12 March 2023
1772/ER

222 TEMPLEOGUE ROAD ROAD – TRAFFIC/ROADS - SAFETY ISSUES

Figure 1 – Extract TII Design Guidance

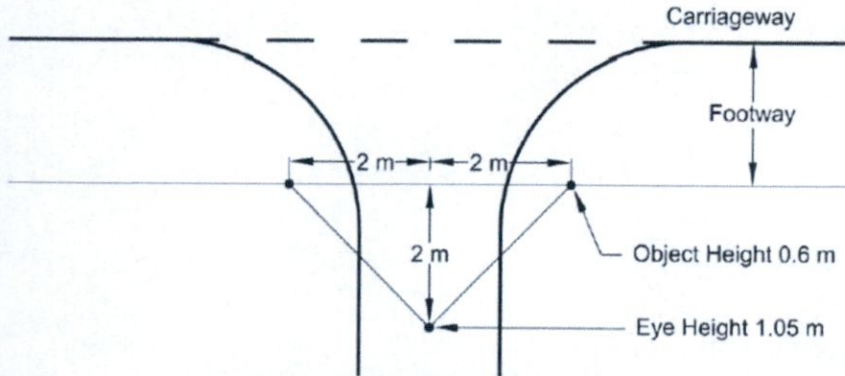
With respect to driveways, we include below as **Figure 1** the relevant extract (paragraph 5.6.3.7) in terms of the appropriate design to provide visibility to pedestrians on a footpath.

Where an emerging vehicle crosses a footway at a lightly used direct access - for example from the driveway of a single dwelling - pedestrians may not have sufficient warning of its approach where there is no clearly formed differentiation in the level between the footway and the vehicle crossing point. Under these conditions, the designer shall provide visibility envelopes to the back of the footway, 2m on either side of the centre of the access, from 2m back from the back edge of the footway along the centreline of the access as shown in Figure 5.17. The driver's eye height shall be taken as 1.05m and the object height at the back of footway shall be taken as 0.6m to make clear the presence of a small child.

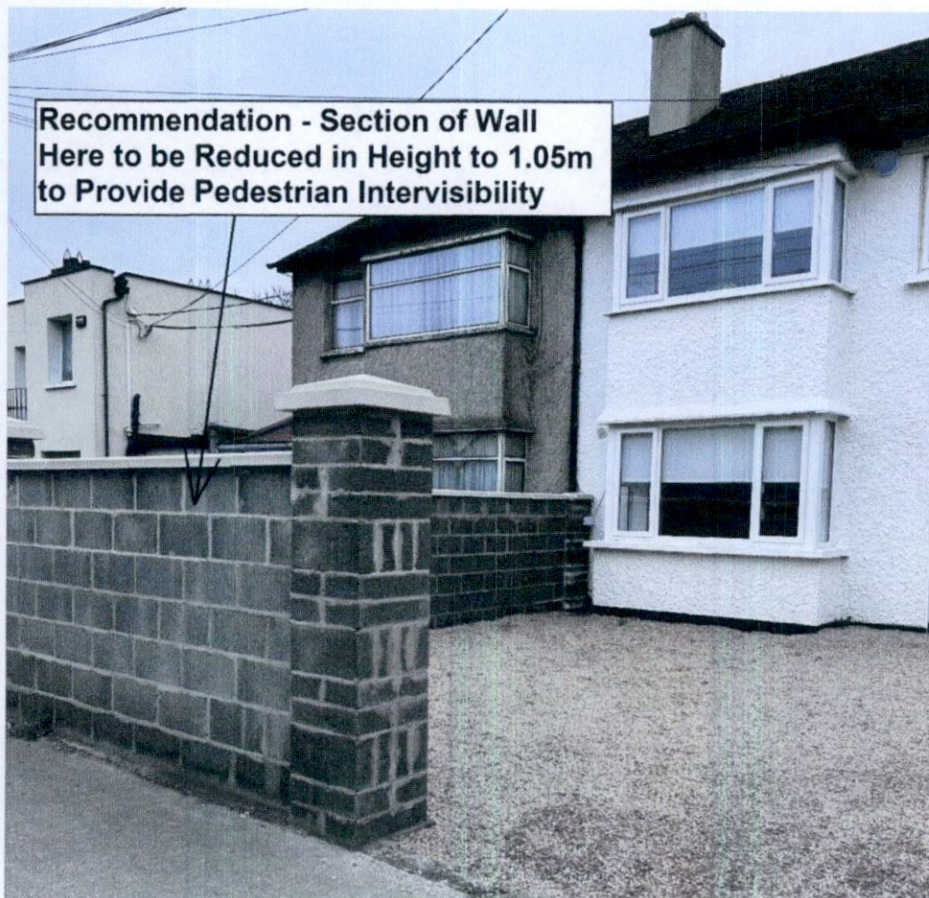
In terms of these National Roads TII Design requirements it would be necessary to make some adjustments to the eastern (Templeogue Village Side) boundary walls at the driveway, as illustrated in the annotated image below.

However, the eastern portion of the boundary walls (Templeogue village side) need to be adjusted in height to 1.05m in order provide the required pedestrian intervisibility for vehicles exiting in forward gear.
